Subject: Submittal of Honeywell's responses to the June 9, 2011 ADEQ and EPA comments on the *Final Focused Human Health Risk Assessment (FHHRA) Report, Honeywell 34th Street Facility, Phoenix, Arizona* dated March 2011

Attachment 1
Honeywell Responses to the June 9, 2011 ADEQ
and EPA Comments on the Final FHHRA Report
Dated March 2011

FIGURE 1
UNDERGROUND STORAGE TANK
GROUNDWATER MONITORING WELLS
FROM WHICH FREE PRODUCT
HAS BEEN RECOVERED
Honeywell 34th Street Facility
Phoenix, Arizona

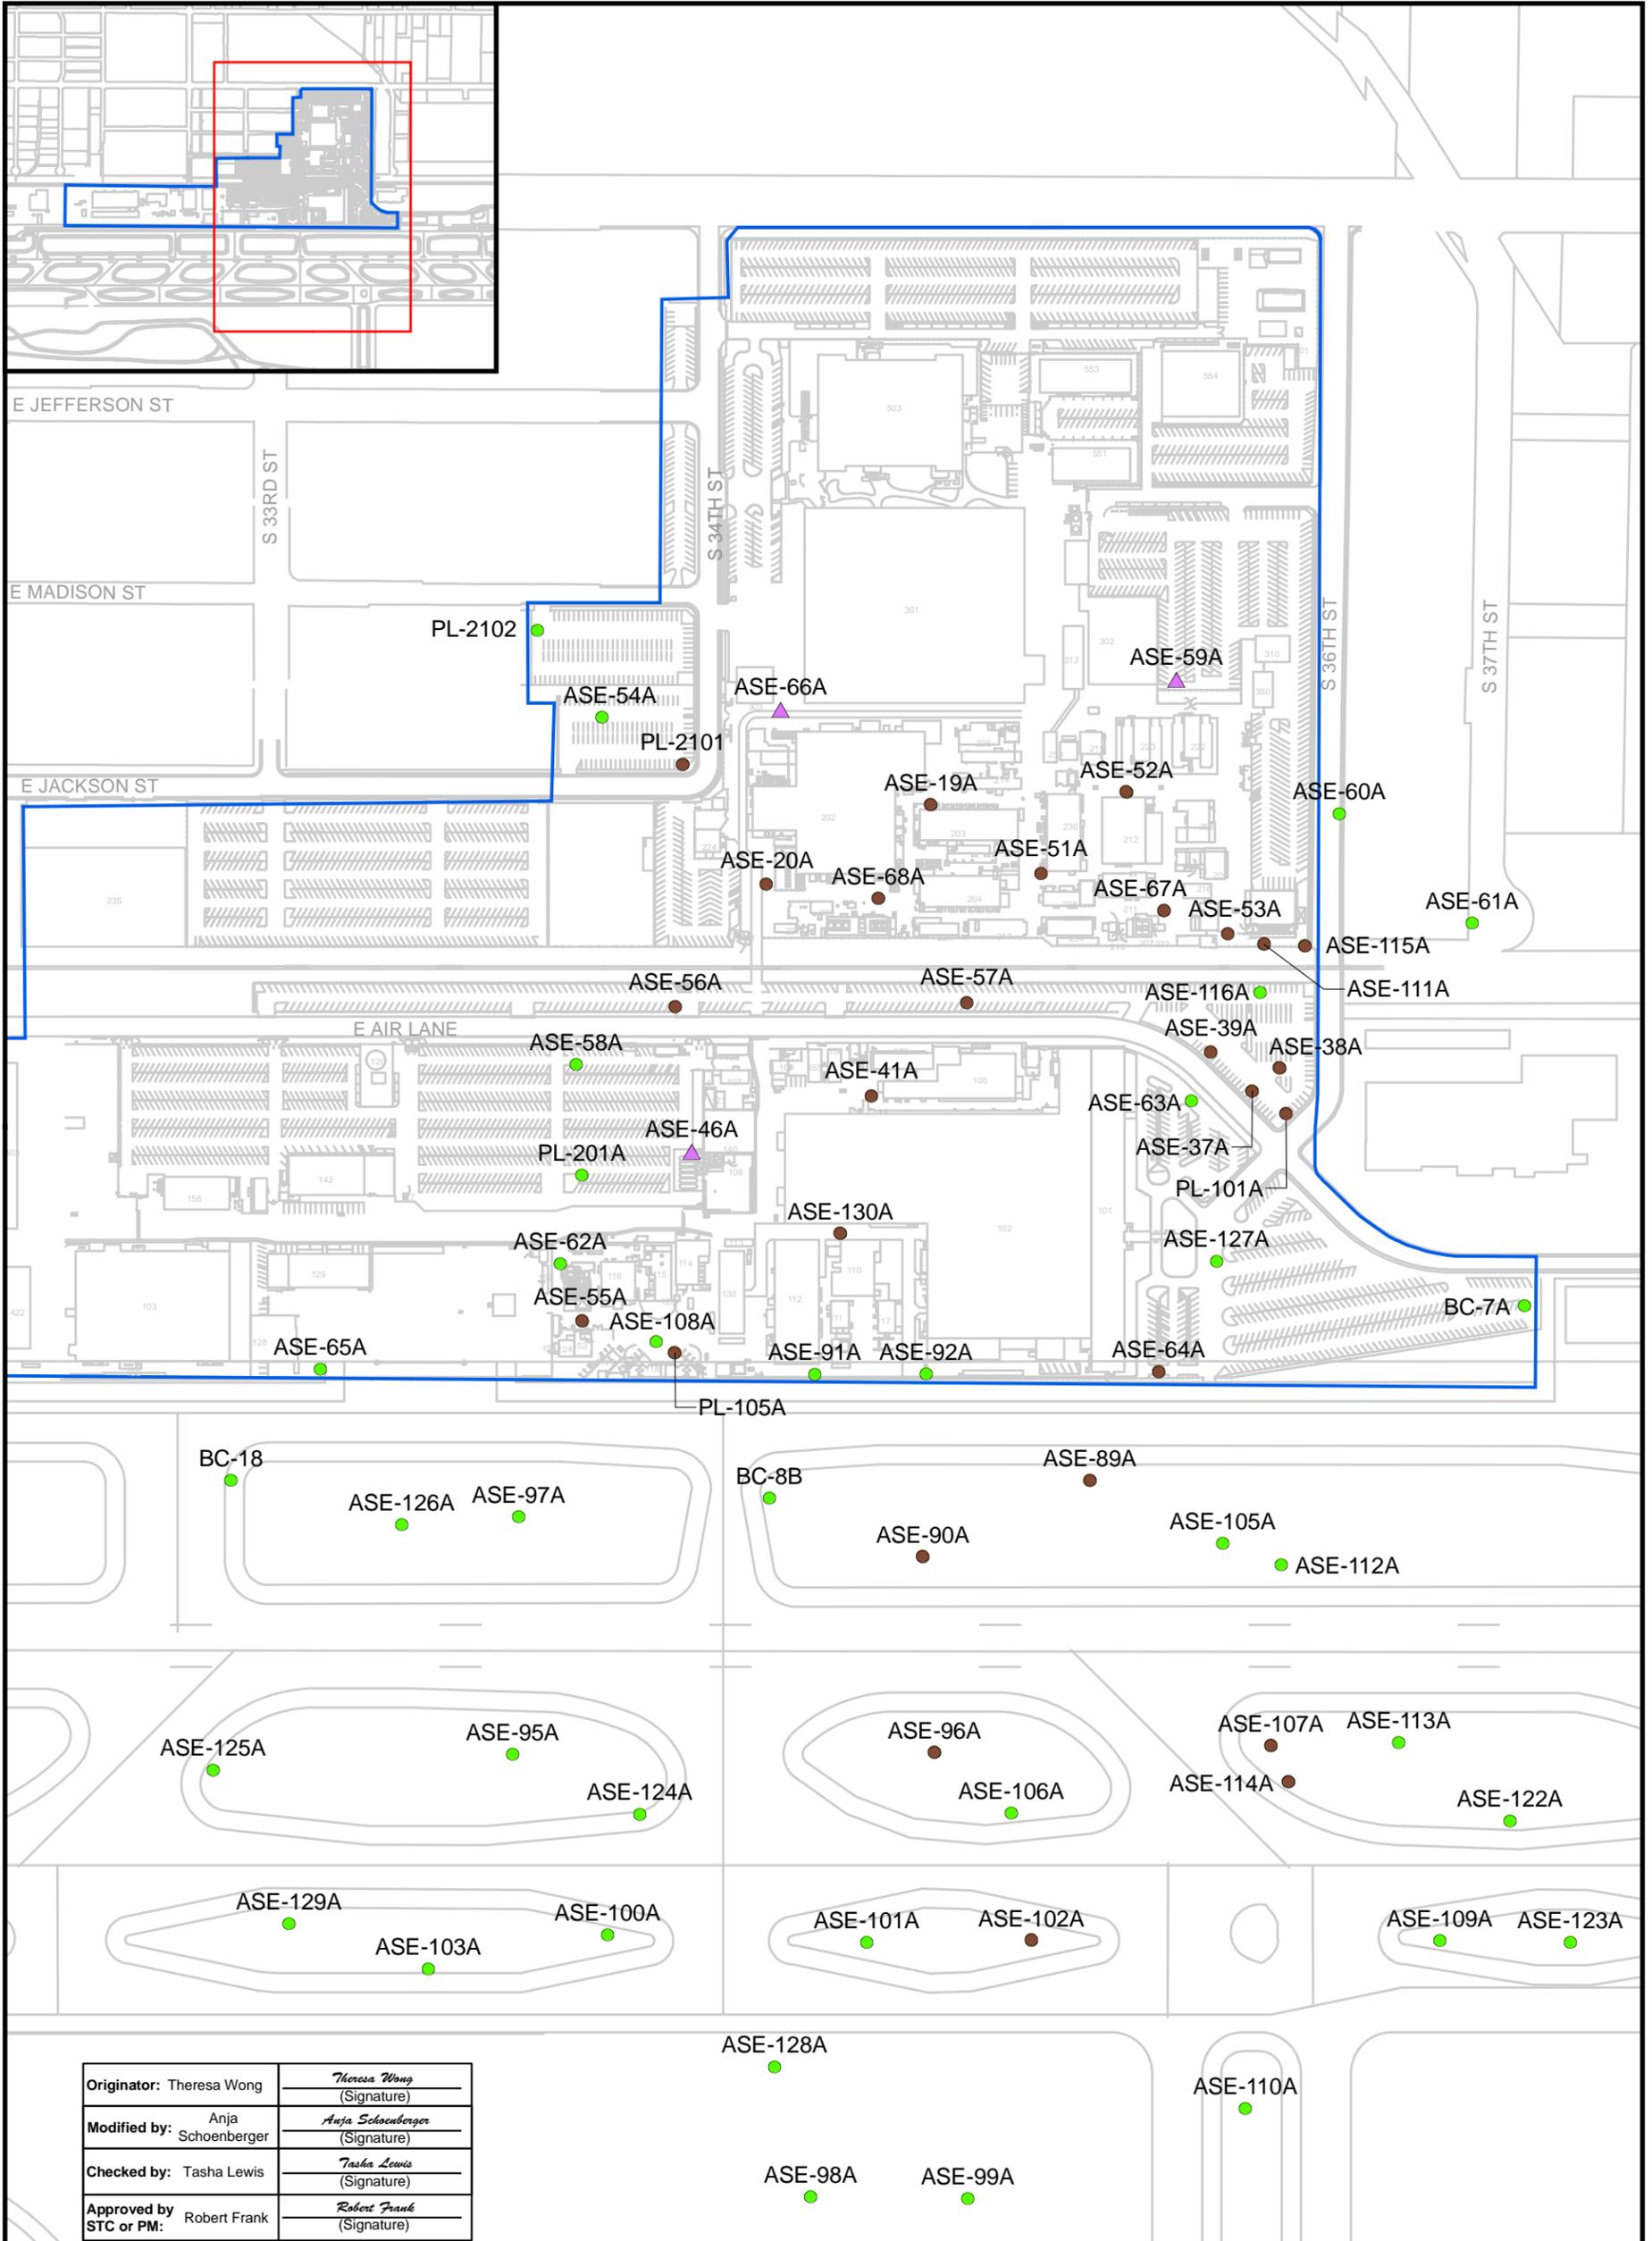
| Comment No. | Pages | Section | Comment | Response |
|--------------------|--------------|----------------|--|---|
| 17 | | 1.2.5.4 | Specify area and adjacent buildings for free-product removal action discussed in 1.2.5.4. | The free-product removal specified in Section 1.2.5.4 (7,500 gallons total) refers to free-product recovery from 27 different Honeywell monitoring wells distributed across Area 1 and Area 2 of the Facility. As part of this response, a figure of the Facility identifying the monitoring wells from which free product has been recovered to show the proximity of the wells to the Facility buildings is provided (see attached figure). The two monitoring wells specifically referred to in Section 1.2.5.4 (ASE-19A and ASE-20A) are located on opposite sides (northeast and southwest) of Building 202 in Area 2 of the Facility. The Revised Final FHHRA will be clarified accordingly. |
